Revisions of SoLID Wiring Diagrams

Mary Ann Antonioli
2022-10

Two examples of revised drawings are A00000-16-03-0313 and A00000-16-03-0260.

FIG 1. Revised drawing A00000-16-03-0313.

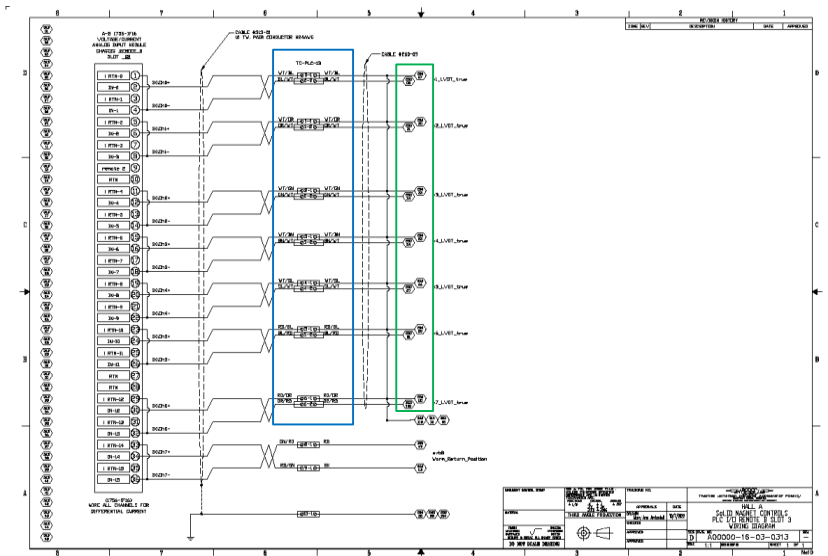
In drawing 0313, a second level of PLC connections was added to terminal strip TS-PLC-13, blue box in Fig. 1. This involved rewiring, renumbering the PLC connection, changing the wire colors, and updating the connection notes (green box).

FIG. 2. Page 1 of the 3-page drawing A00000-16-03-0260.

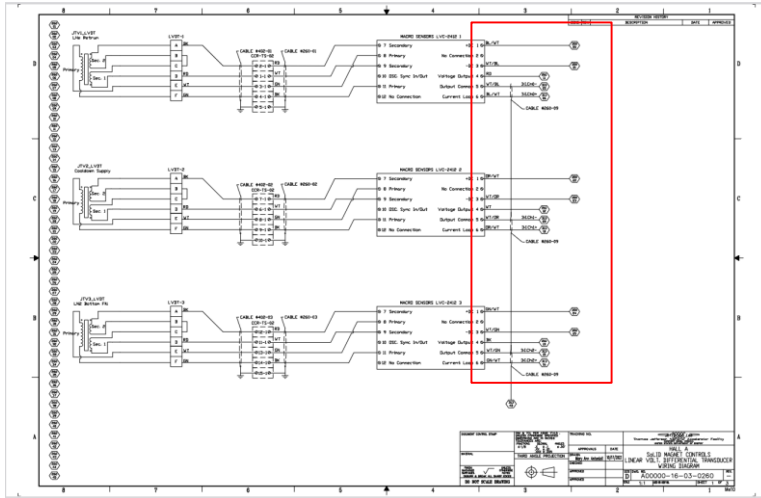
Wiring in drawing 0313 is connected to wiring in drawing 0260, Fig. 2; therefore, drawing 0260 also needed to be revised. The wire colors of 0260 were changed to match drawing 0313 and the connection notes were updated due to the rewiring in 0313. The area changed is in the red box.
